# OPTIONAL SERVICE BULLETIN

## OSB 42-098/1

## OSB 42NG-090

Installation of new power supplies for the taxi- and landing lights.

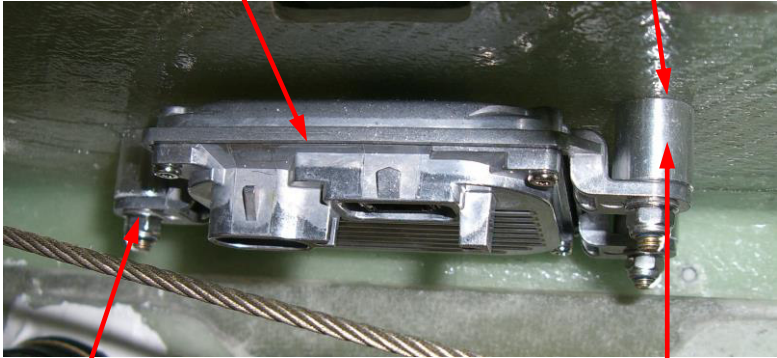
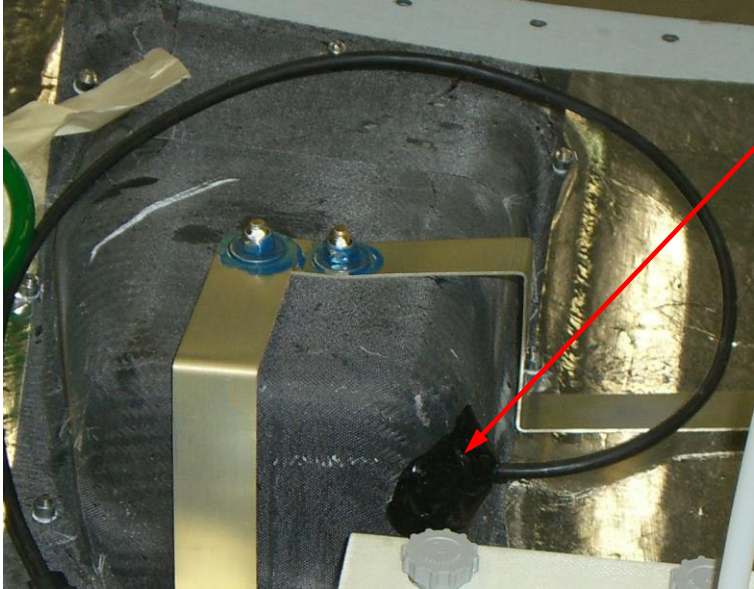
1	Set the ELECT. MASTER, TAXI light and LANDING light switches to OFF.
2	Set the LH BATT, RH BATT circuit breakers open (pull).
3	Remove the pilot and co-pilot seats i.a.w. AMM Section 25-10.
4	Remove the taxi- and landing light power supplies (electronic controllers) i.a.w. AMM Section 33-40.
5	Remove the taxi- and landing lights i.a.w. AMM Section 33-40.
6	Remove the electrical cables that route from the power supplies to the lights.
7	Drill new holes for the power supplies i.a.w. drawing D64-5320-32-00x01.

8	<p>Install the new power supplies as shown below.</p> <div data-bbox="359 387 802 432">Power Supply: XV4D-24-35-SHS-WT</div> <div data-bbox="943 320 1268 439">           Screw: LN 9037-05 026            Typ. 3x <b>(backside)</b>            Washer: DIN 9021-A5.3-A2            Typ. 3x <b>(backside)</b> </div>  <div data-bbox="359 936 675 1030">           Washer: DIN 125-A5.3-A2            Locknut: DIN 985-M5-A2            Typ. 3x         </div> <div data-bbox="963 936 1279 1005">           Bushing: BU2-15-06-0150-B            Typ. 3x         </div>
9	<p>Route the new double shielded cable assemblies (P/N: XVLG-2-S) as the previous cables and connect them the power supplies and the taxi- and landing lights. Modification to the structure is necessary to route the connector through it. Make a cutout of 25 mm x 15 mm.</p>
10	<p>Install the taxi- and landing lights i.a.w. AMM Section 33-40.</p>
11	<p>Seal the connector feed through with sealing compound (Easy Gasket or equivalent).</p>
